Access Compliance Report

Public Rights-of-Way

(Curb Ramps)

Intersection ID: N/A	Main Street: ARDREY_KELL_DR	Cross Street: N/A	Location: SE
ADA ID: C3E801DD65C8	Ramp Type: Para	Initial Pass/Fail: Fail	Overall Compliance: No
Severity Score: 12.5			
Codes/Mitigation Info/Possible Solution		Field Measurements/Component Compliance

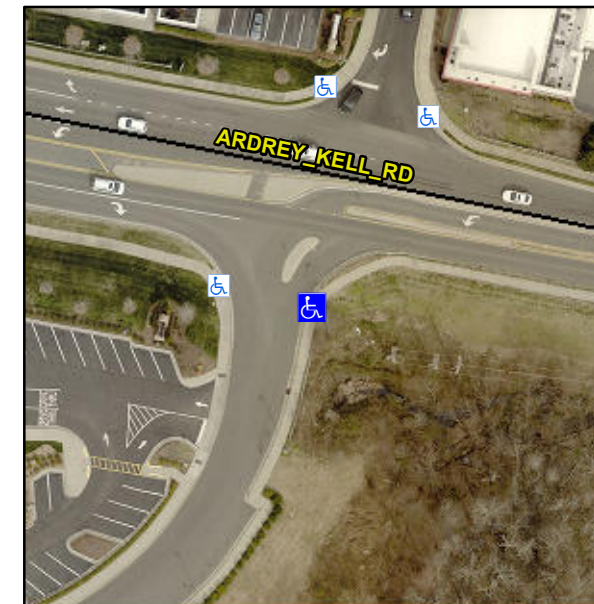
RT RP < 5%

R304.3.2

Compliance	Description	Data	Compliance	Description	Data
N/A	Ramp Length LT (in)	68.0	N/A	Ramp Length RT (in)	74.0
Yes	Ramp Width LT (in)	72.0	Yes	Ramp Width RT (in)	68.0
No	Ramp Slope LT (%)	9.8	Yes	Ramp Slope RT (%)	0.1
Yes	Ramp XSlope LT (%)	0.6	Yes	Ramp XSlope RT (%)	0.5
N/A	Landing Length (in)	N/A	N/A	DWS Provided?	N/A
N/A	Landing Width (in)	N/A	N/A	DWS Contrast?	N/A
N/A	Landing Slope (%)	N/A	N/A	DWS Length (in)	N/A
N/A	Landing X Slope (%)	N/A	N/A	DWS Full Width?	N/A
N/A	Landing Curb? (Y/N)	N/A	N/A	DWS Offset (in)	N/A
N/A	Shared Landing?	N/A			
N/A	Gutter Ponding?	N/A	N/A	Gutter Slope (%)	N/A
N/A	Gutter Lip Ht (in)	N/A	N/A	Gutter X Slope (%)	N/A
N/A	Painted X Walk1?	No	N/A	Painted X Walk2?	N/A
	X Walk 1 Direction	To W		X Walk 2 Direction	N/A
N/A	X Walk 1 Width (in)	N/A	N/A	X Walk 2 Width (in)	N/A
	X Walk 1 Slope (%)	3.7		X Walk 2 Slope (%)	N/A
	X Walk 1 X Slope (%)	3.1		X Walk 2 X Slope (%)	N/A
N/A	Ramp inside XWalk1?	N/A	N/A	Ramp inside XWalk2?	N/A

Remove & Replace Entire Ramp.
